SUBJECT: **Permit Modification Request for TIP No. R-2809B**, Wake County, NC  
DOT Division 5, Federal Aid No. STP-98(1), State Project No. 8.1402501,  
USACE Action ID 199601836, and DWQ Project No. 010550, \$475 Debit  
Work Order WBS Element 34503.1.1

Subject: **Revised Mitigation Request**, Wake Forest Bypass, Wake County, Federal Project No. STP-98(1), State Project No. 81402501, TIP No. R-2809B.

PROJECT: 8.1402501 (R-2809B)  
NC 98 WAKE FOREST BYPASS

SHEET 6 OF 20

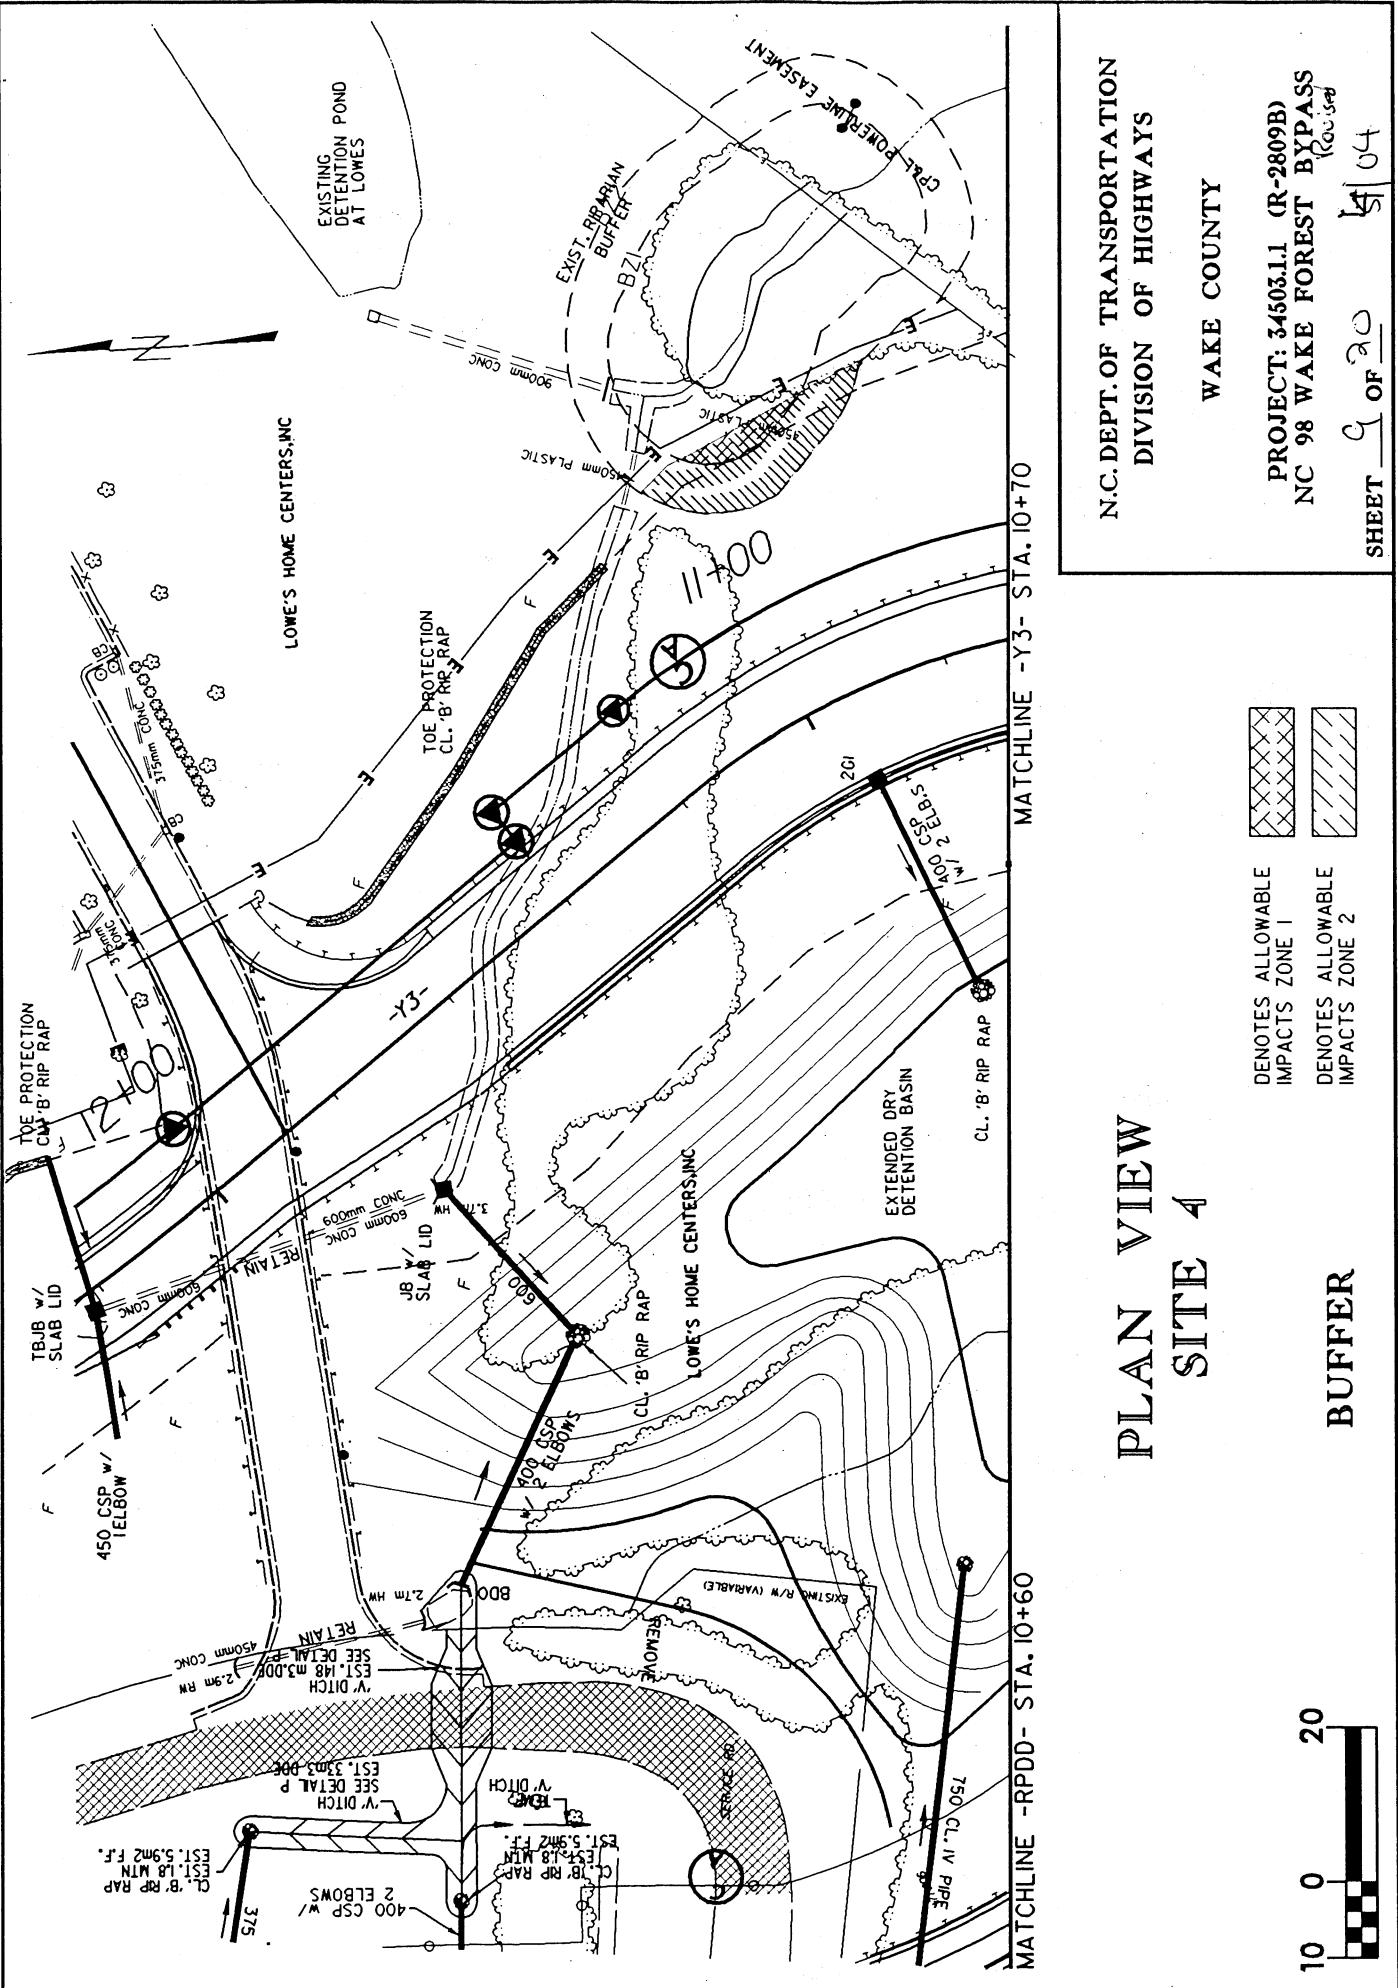
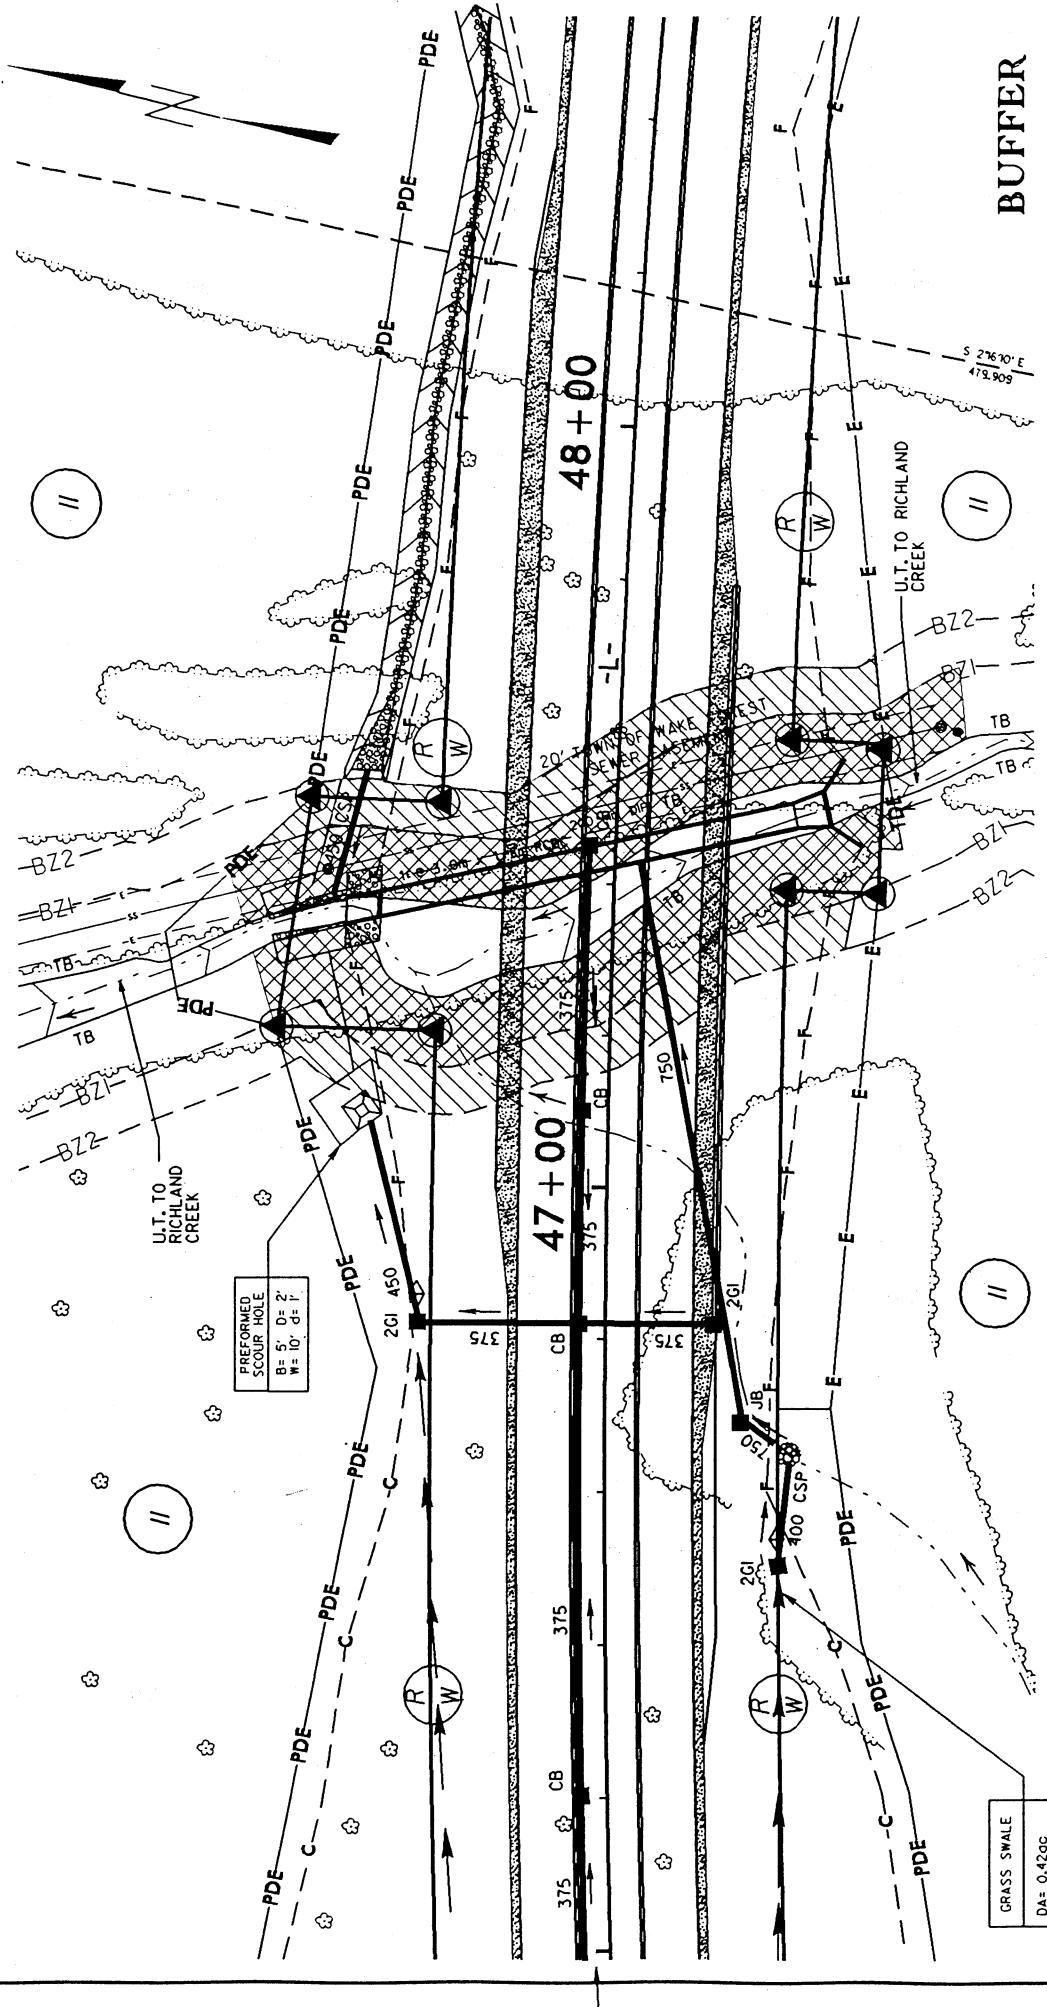
Site 3, Sheet 6 of 20

Station -Y1- 16+88L/ -RPB- 11+01L

Station -Y1- 16+98R/ 17+70R

The entire temporary drainage easement will be required to allow equipment access for the construction of the bridge.

**Impact change: increase of 9,248 ft<sup>2</sup> of Mitigable Buffer Impacts**
